**Salas O'Brien**  
 REVIEWED  REVISIT AND RESUBMIT  REVIEWED AS MODIFIED  
 Corrections or comments made on the shop drawings during this review do not relieve the Contractor from compliance with requirements of the drawings and specifications. This check is only for review of the general compliance with the design concept of the project and the general compliance with the information given in the contract documents. The Contractor is responsible for confirming and coordinating all quantities and dimensions, selecting fabrication processes and techniques of construction, coordinating all work in a safe and satisfactory manner.  
 Date: Sep 12, 2024 Signed: CG  
 Impression Engineering, a company of Salas O'Brien

**RITESTART LIMITED**  
 SHOP DRAWING / SUBMITTAL REVIEW  
 This review is for general conformance with the contract, plans and specifications only. Review is subject to Subcontractor or Supplier performance within the confines of the contract documents. Review stamp does not relieve the subcontractor or supplier of contract responsibility for any deviation from the contract requirements.  
 REVIEWED  REVISIT AND RESUBMIT  REVIEW AS NOTED  REJECTED  FOR RECORD ONLY  NOT R

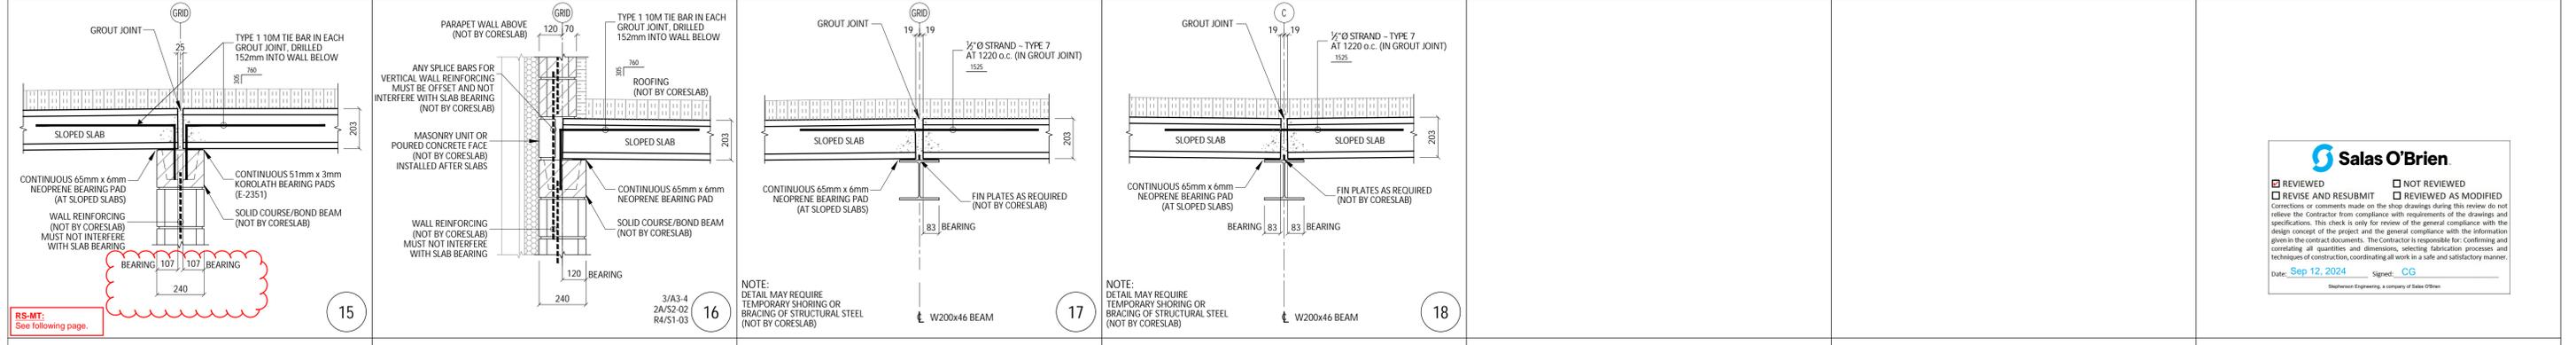
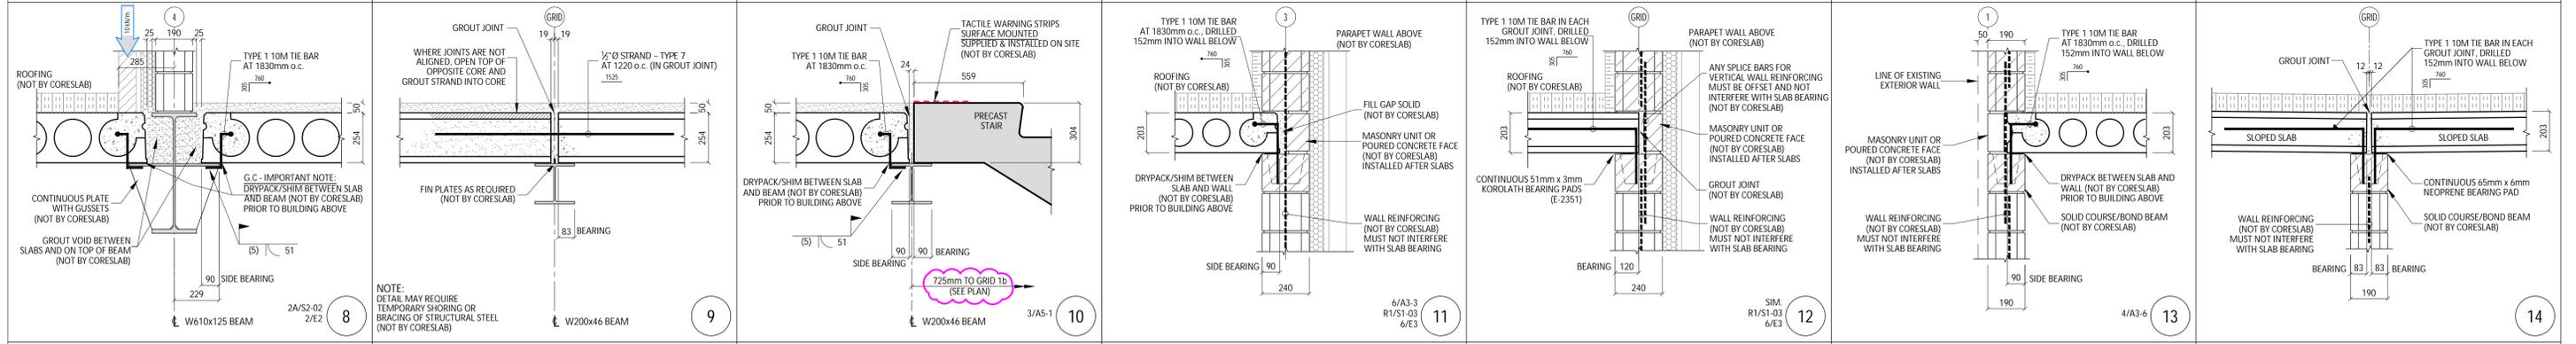
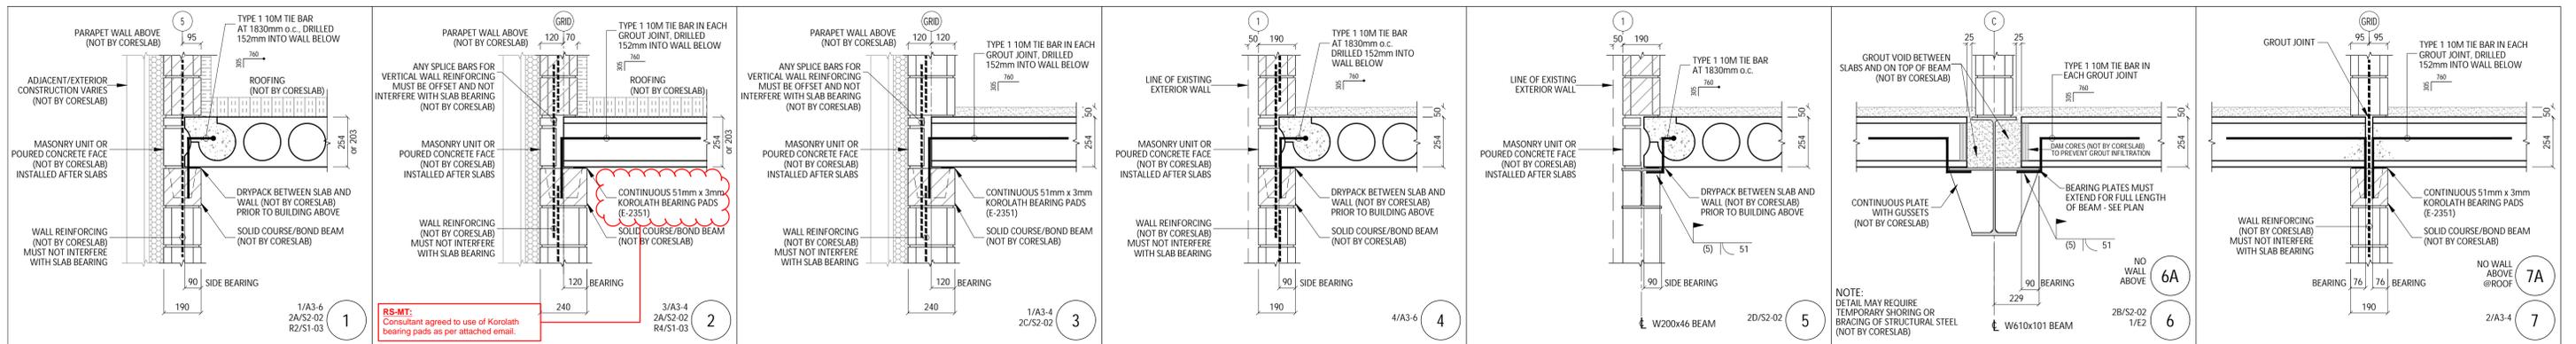
ALL penetrations that require rough opening sizes of 150mm (6") and larger must be indicated on these shop drawings. Verify / Provide Size & Locations. Coreslab has anticipated that 1 (one) web/strand will be severed in slabs where toilets occur.

Verify all connection details and bearing conditions
